SECTION 009113 – ADDENDUM TWO

- A. Project Name: Alliance Fire Station
- B. Owner: Madison County
- C. Architect: Dale Partners Architects, PA
- D. Architect Project Number: 22019
- E. Date of Addendum Two: 1 November 2022

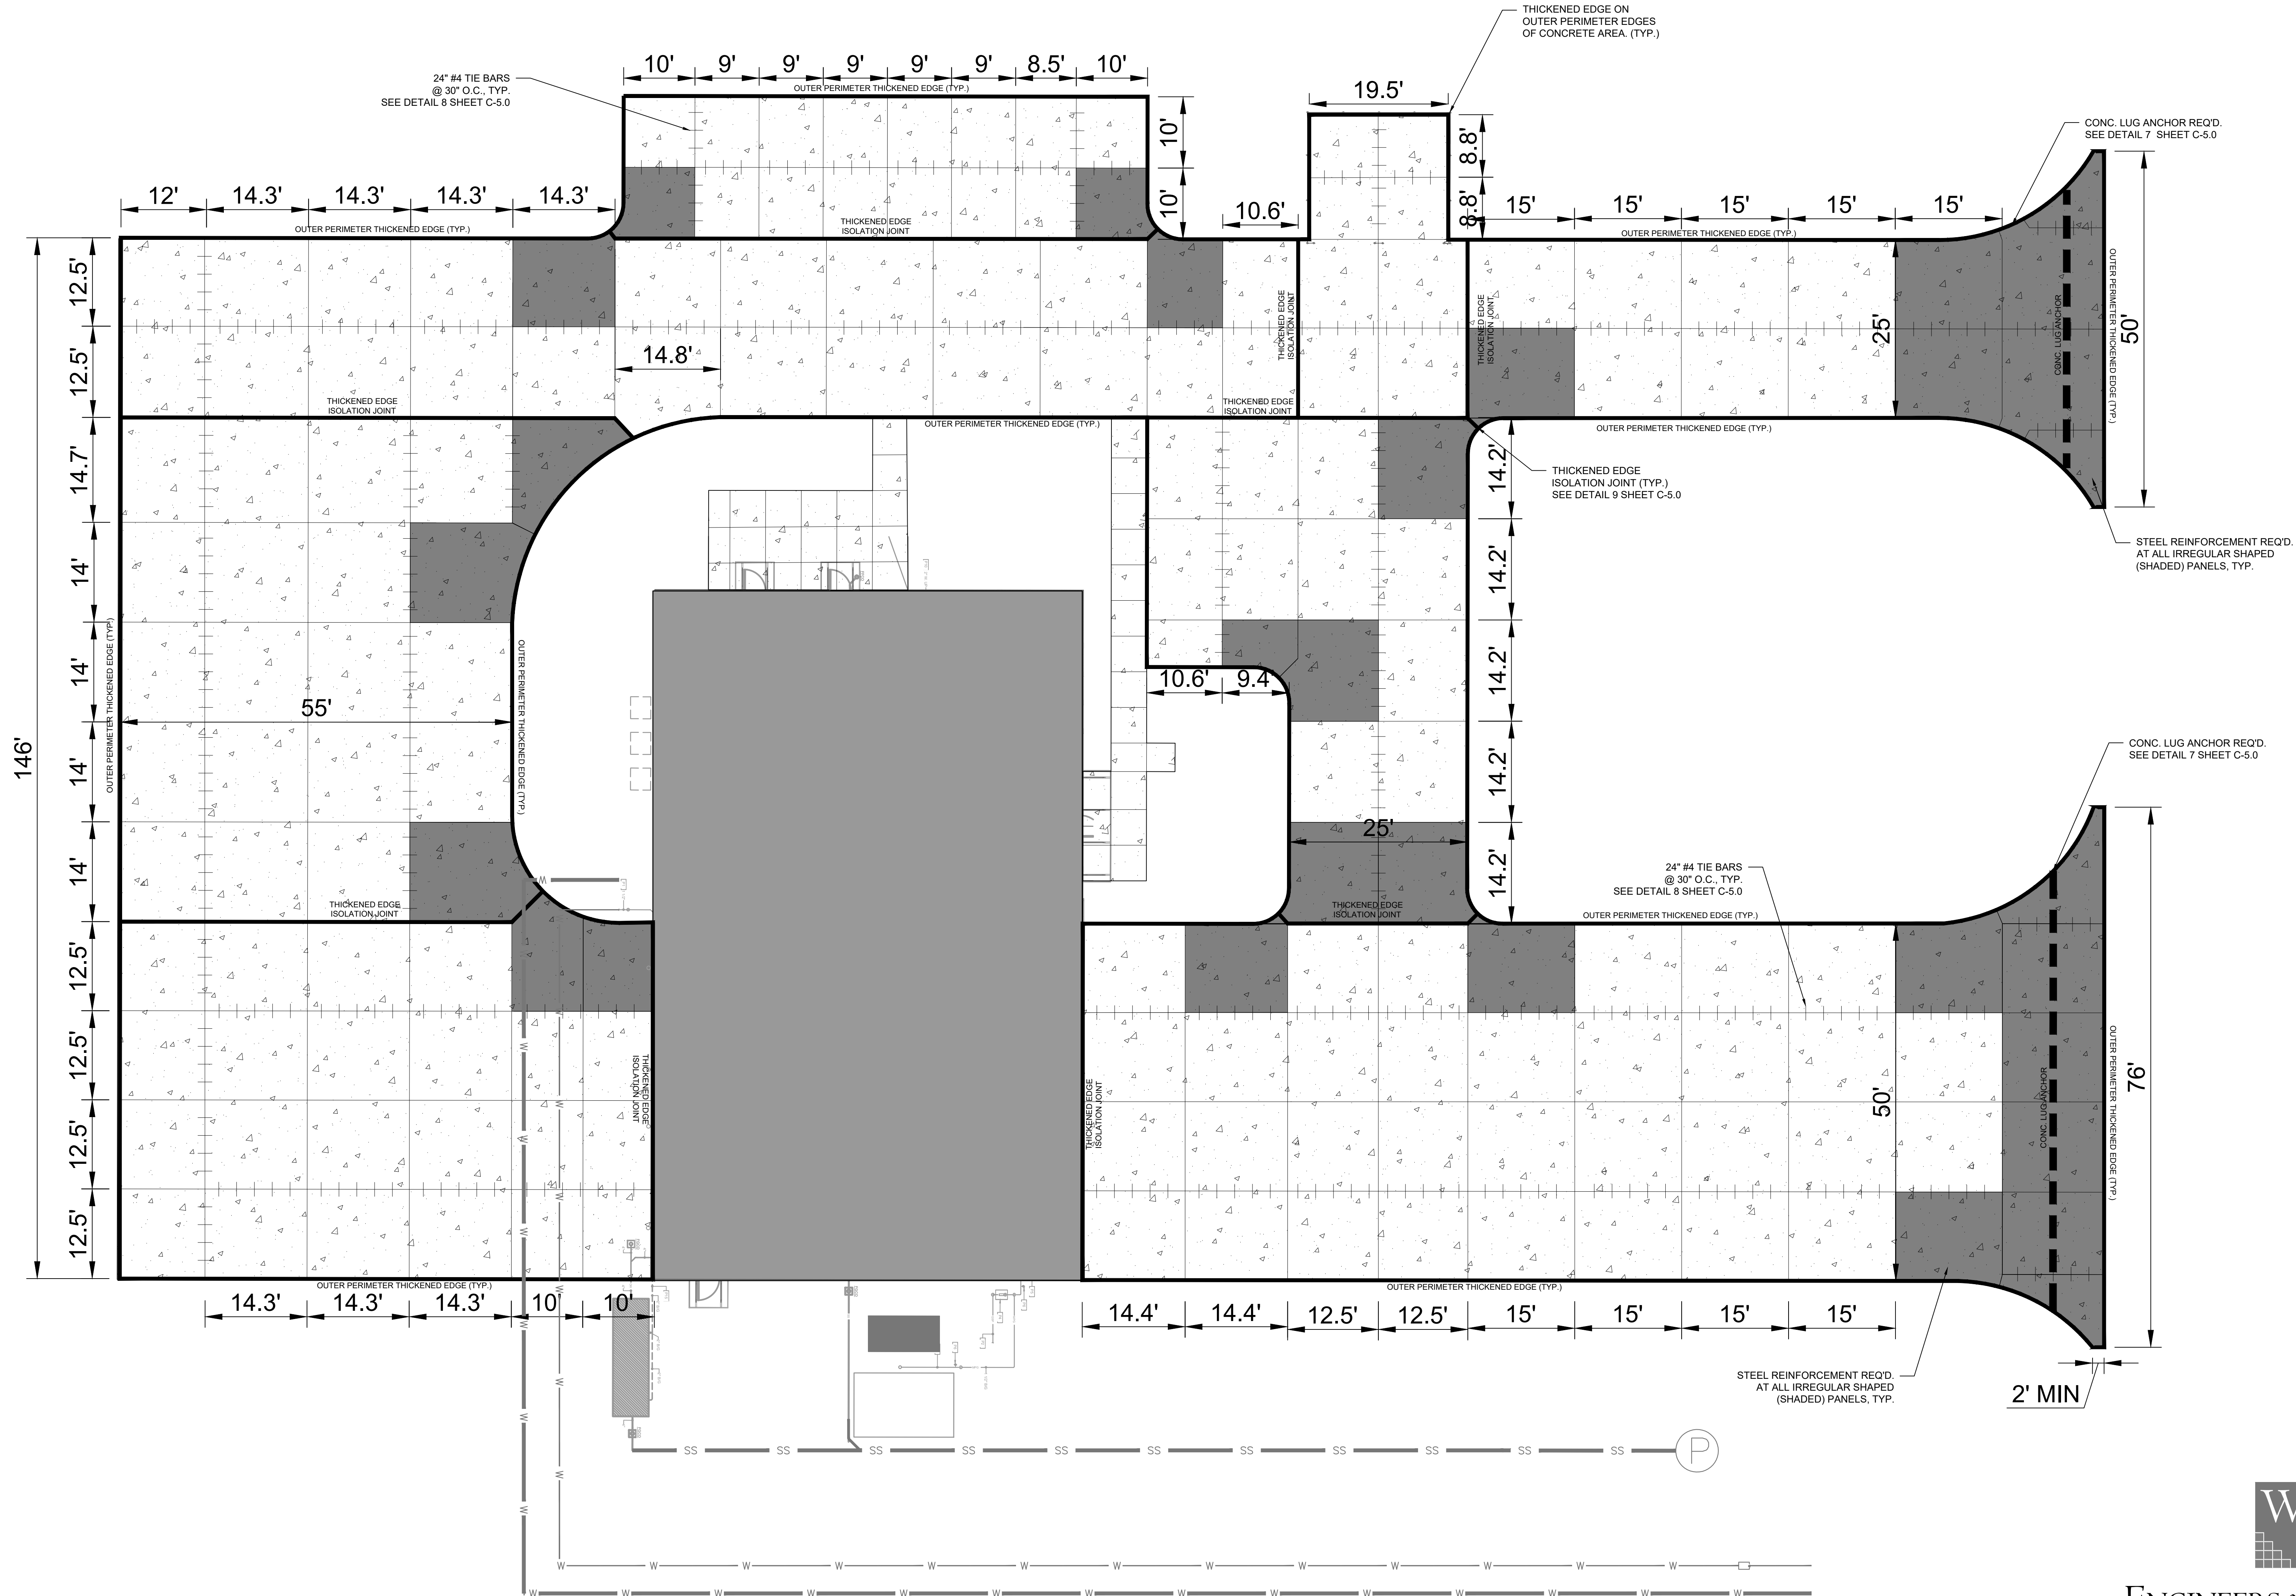
- B. Civil Sheet C4.0 – CONCRETE JOINT LAYOUT. Delete the sheet in its entirety and replace with the attached. Revised concrete joint layout to add more tie bars, move lug anchors, and revised notes.

1 MEZZANINE FRAMING PLAN
1/4" = 1'-0"

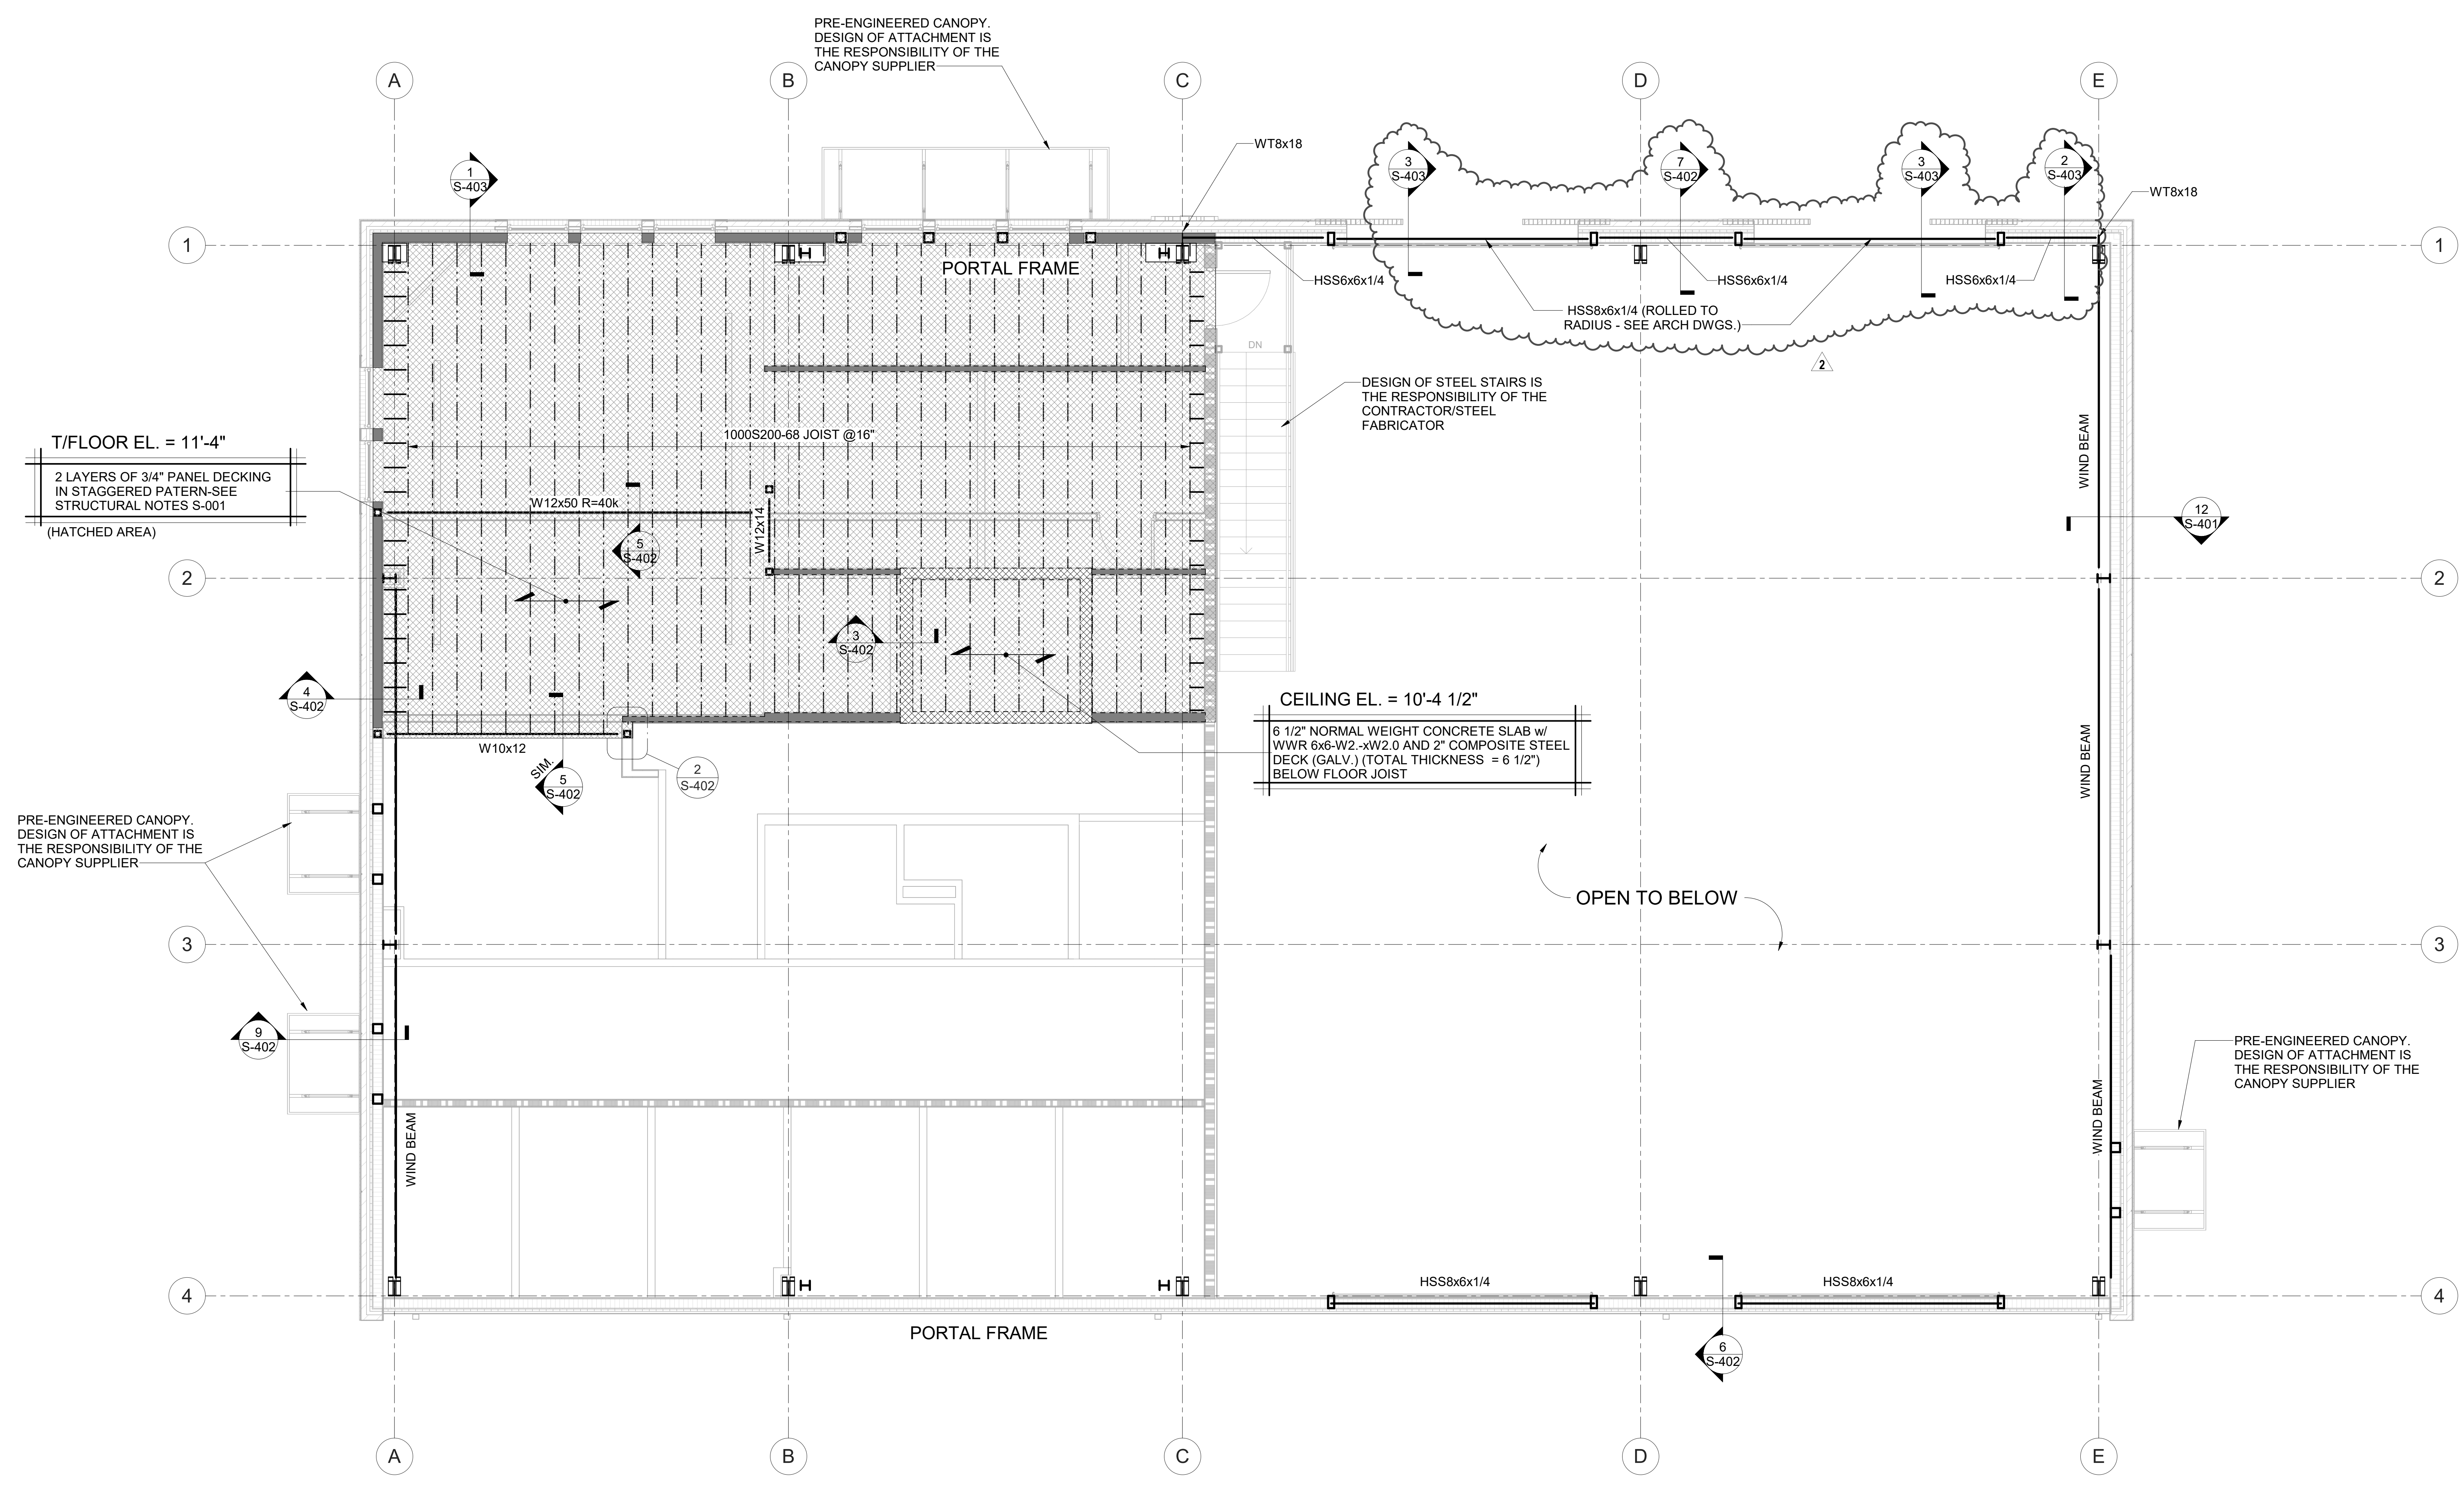
- D. Structural Sheet S-102 – MEZZANINE FRAMING PLAN. Delete the sheet in its entirety and replace with the attached. Added Sections 7/S402, 2/S-403 and 3/S-403.

1 ROOF FRAMING PLAN
1/4" = 1'-0"

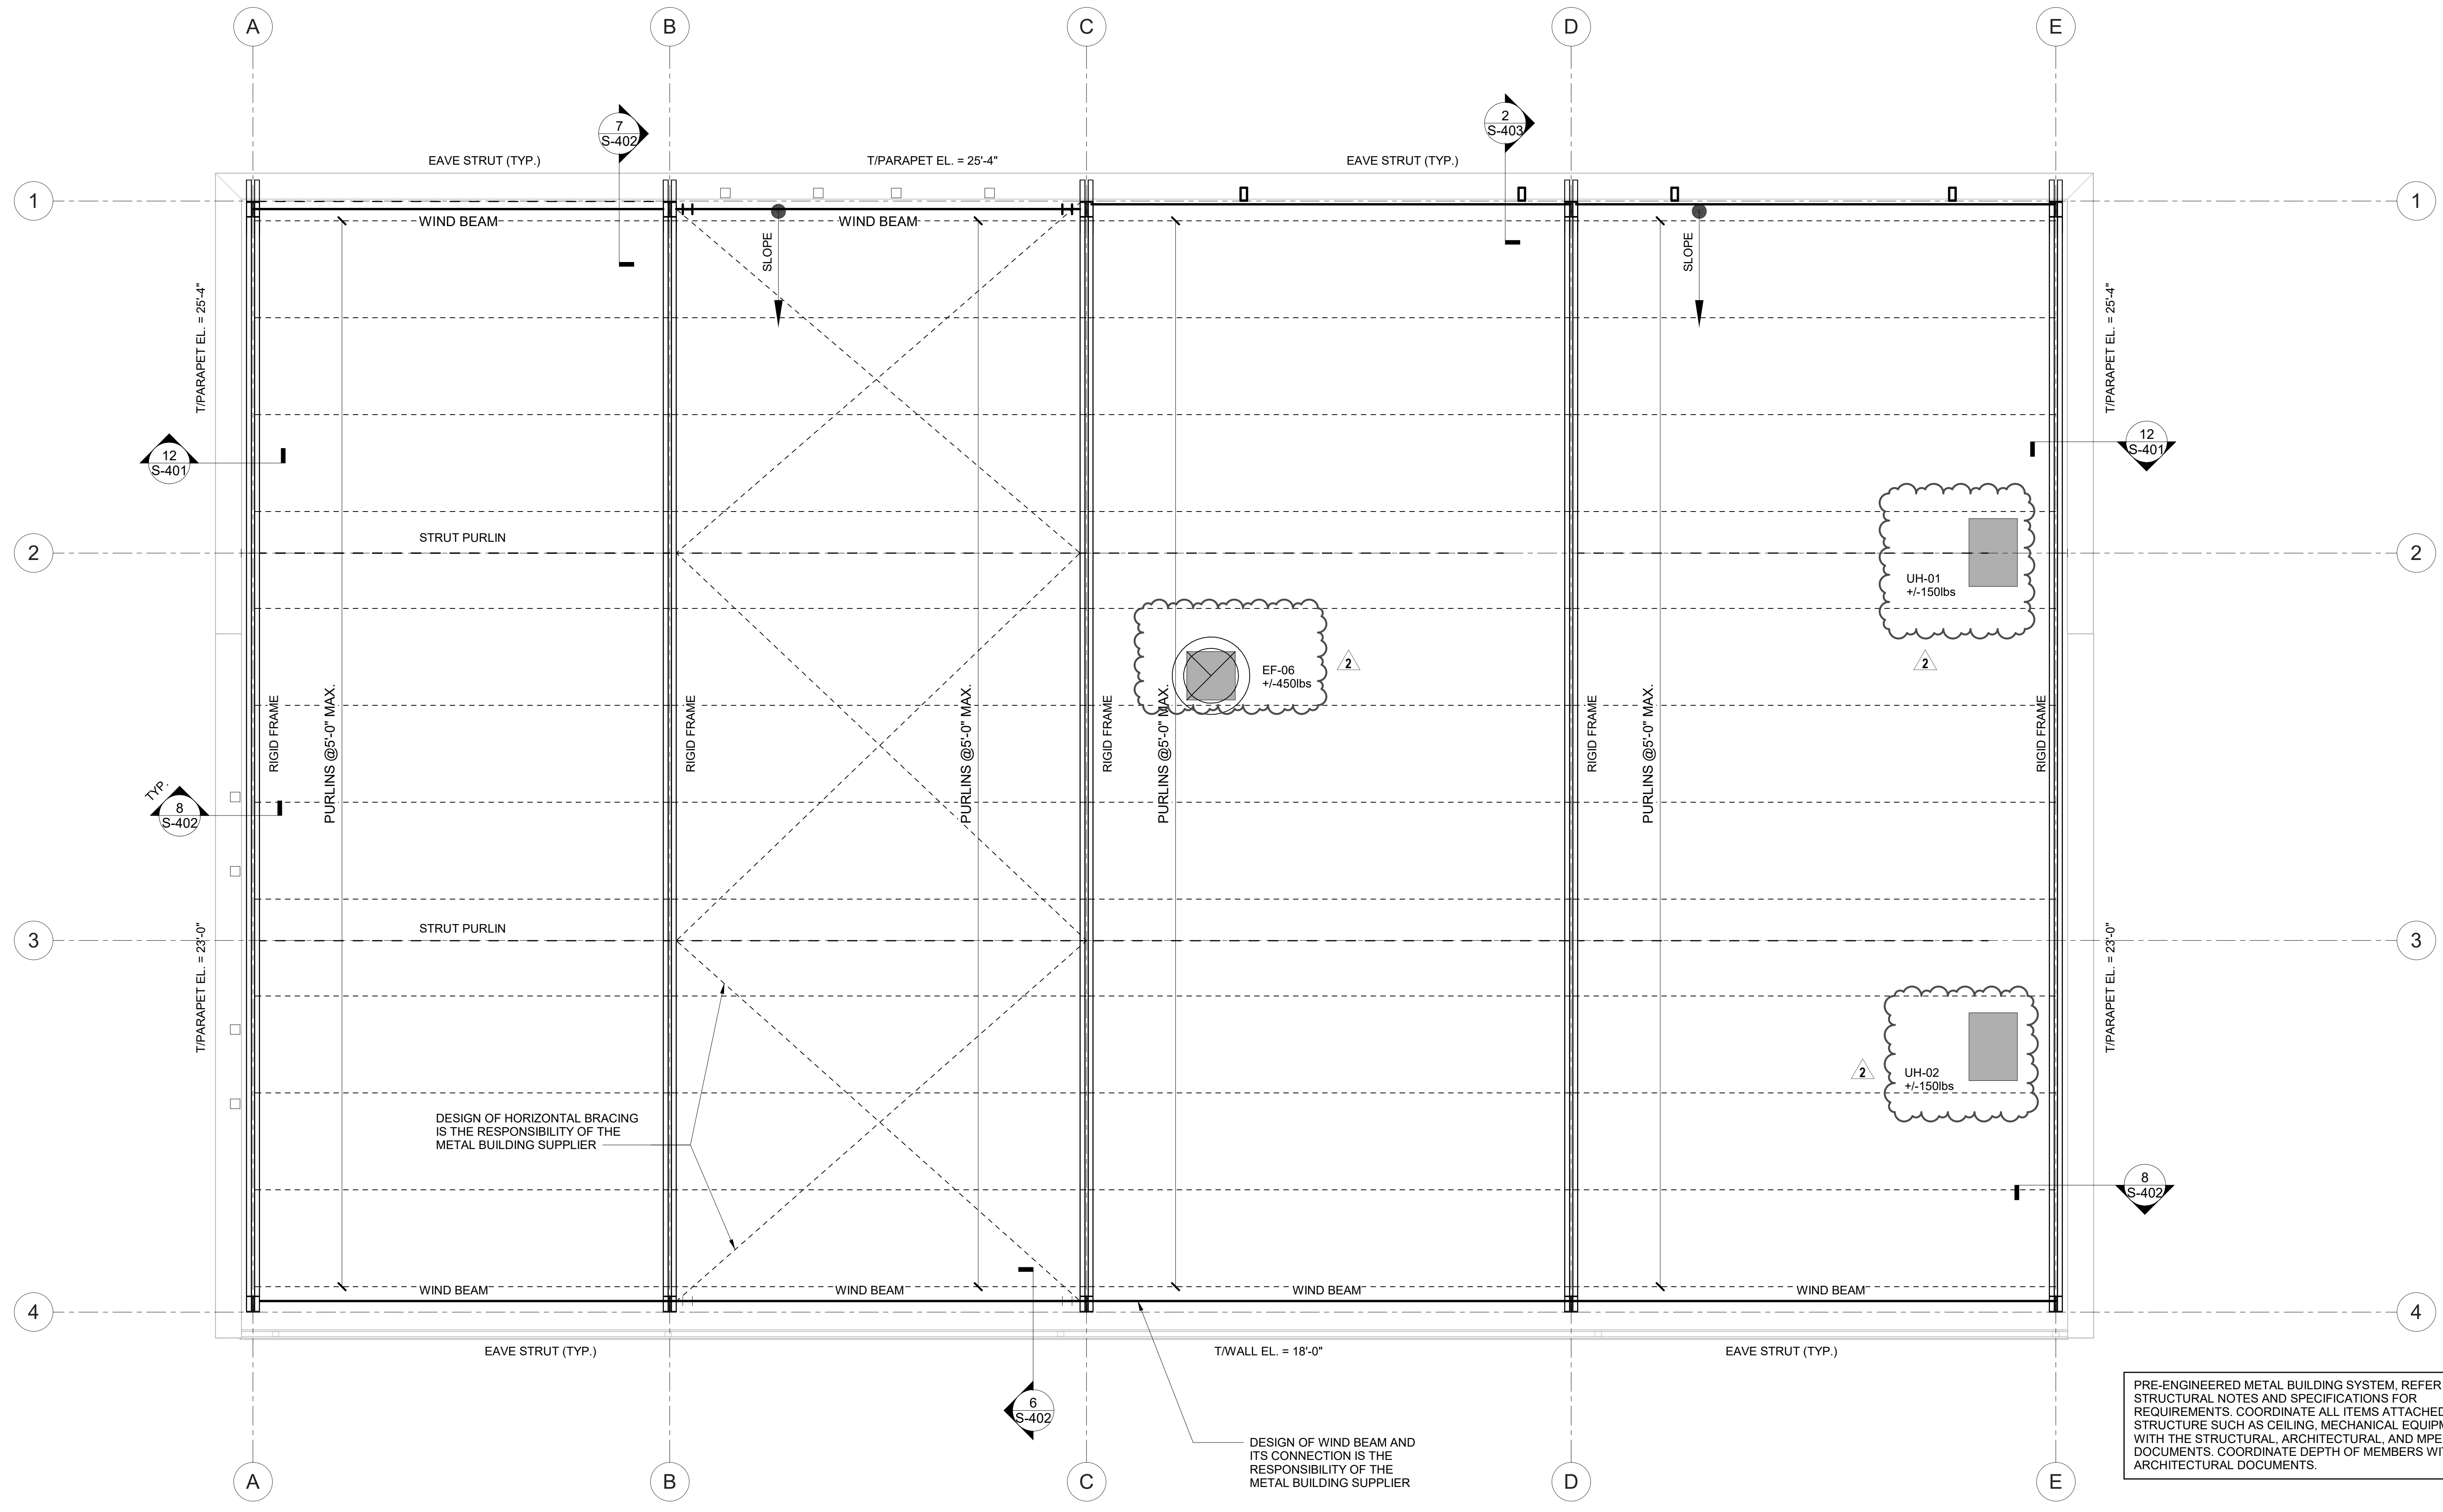
- E. Structural Sheet S-201 – ROOF FRAMING PLAN. Delete the sheet in its entirety and replace with the attached. Added Mechanical equipment and weights to roof plan.
